# **Technical Service Bulletin**

SRS UPDATES: SEAT SLIDE SENSOR, SEAT BELT SWITCH ADDED TO CIRCUIT DIAGRAMS –			No:	TSB-16-52B-004
			DATE:	June, 2016
			MODEL:	2014-15 Mirage
CIRCULATE TO:	[ ] GENERAL MANAGER	[X] PARTS MANAGER		[X] TECHNICIAN
[X] SERVICE ADVISOR	[X] SERVICE MANAGER	[ ] WARRANTY PROCESSOR		[ ] SALES MANAGER

### SUPPLEMENTAL RESTRAINT SYSTEM (SRS) (CONTINUED)

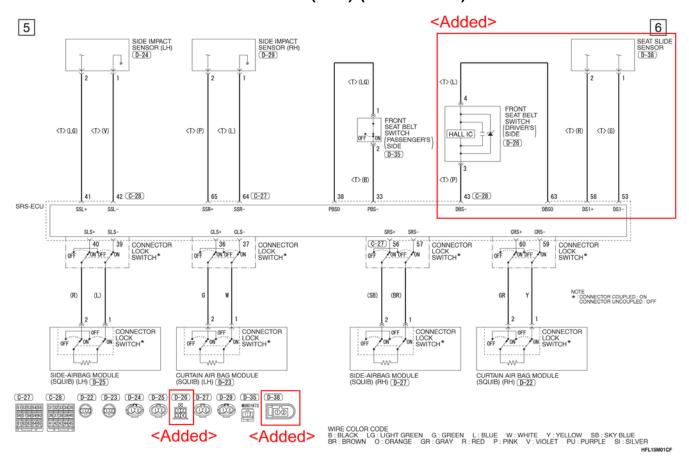
This TSB updates the Circuit Diagrams section of the affected Service Manuals to include the seat slide sensor and front seat belt switch.

Please make the indicated changes to the 2014 and 2015 Mirage Service Manual, Group 90 – Circuit Diagrams –> Supplemental Restraint System (SRS).
